Objection To :- The Uniting Kingscliff Redevelopment (SSD47105958)

I live at 37 Drift Court Kingscliff and <u>am a direct neighbour</u> to the proposed Uniting Kingscliff Redevelopment (SSD47105958). I object to the development in its current form based the items listed below.

Figure 1 Planting along and over Boundary Causing over shadow and View loss

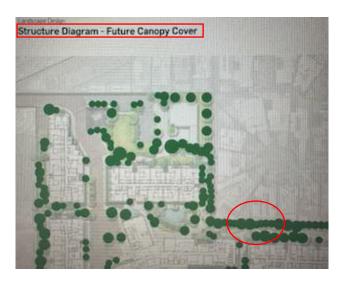
- The landscape design intent presented by the developer, (Appendix AA) shows
 planting along my boundary and future canopy diagrams appear to have been drawn
 OVER my boundary.

Figure 2 View From 37 Drift Court Living Spaces

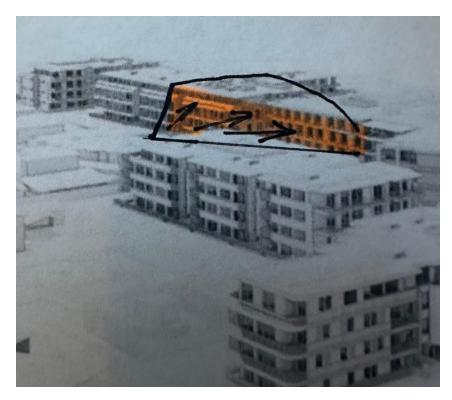
- Loss of any outlook other than Uniting Buildings, with Balcony and Living Areas.
- How do we maintain any view whilst giving ourselves privacy. Approximately 100 full glazed panels will view my house from living spaces.

- Due to constraints because of the shape of our land the only option to get any outlook is towards the northwest and west
- We will lose more than 95% of the horizon and sky we currently see

Figure 9 Expected visual effect

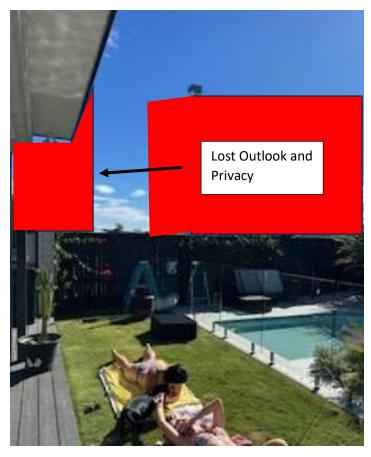
Figure 8 Misleading as to the impact as it only shows the Rac and Not Building C. Photo is also taken from a location that is least impacted at our house. How does this meet Land and Environment Court's photomontage policy standard?

Figure 10 This image shows the outline of House numbers 35 and 37 and will be viewed as one 4 storey, 180 degrees across their western aspect and dominate all views. Note no articulation in buildings.

Figure 21 Coverage calculated across my boundary

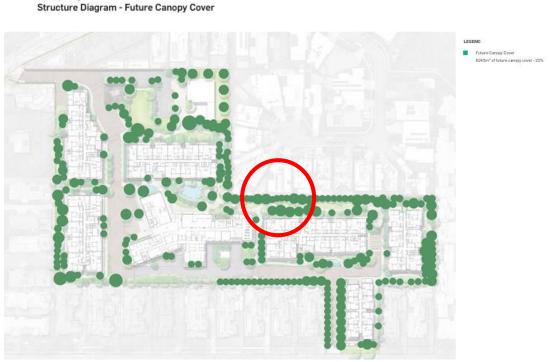
- Intent to use trees on our boundary to soften our outlook
- Trees need to go in deep soil zones that due to the basement only exist on our boundary
- The trees will **block any outlook** we may have and shade our open space and pool making our house **damp and cold** when our house is of passive design designed to absorb warmth in colder months and cool in hotter months.
- Tree coverage has been densified and calculated as tree coverage across my boundary.

Figure 32 Lights shining into bedroom from Uniting Carpark all night. we cannot sleep in the main bedroom on our top floor

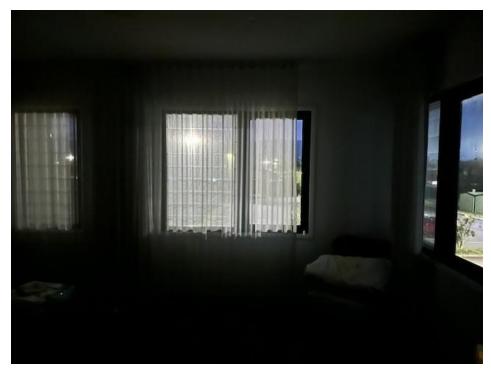
- Light pollution has been an ongoing issue with the Current Uniting aged Care. Unfortunately we had to complain to council because of the light overflow from the carpark adjacent to our main bedroom. Uniting fobbed us off.
- We have during long periods had to relocated to the spare room to get sleep due to the light spill into our property.
- We are concerned the lighting from the buildings, verandahs and external areas will cause a lot of light spill and effect our liveability with larger building adjacent living areas. Uniting have not managed this well in the past.
- How will lighting from top levels not cause a level of light pollution.

Figure 36 Minimal setback of upper level roof

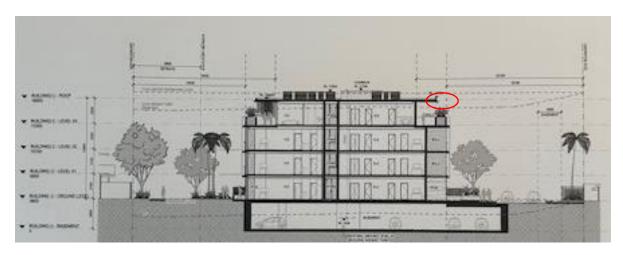
How can an uplift in height over the LEP be justified, at some places more than 3m above the maximum height above natural ground? To get the uplift that has been stated, <u>words</u> have stated that the top level will be stepped back – but this is NOT shown in the diagrams and is non-existent (refer to Figures 36 and 37)
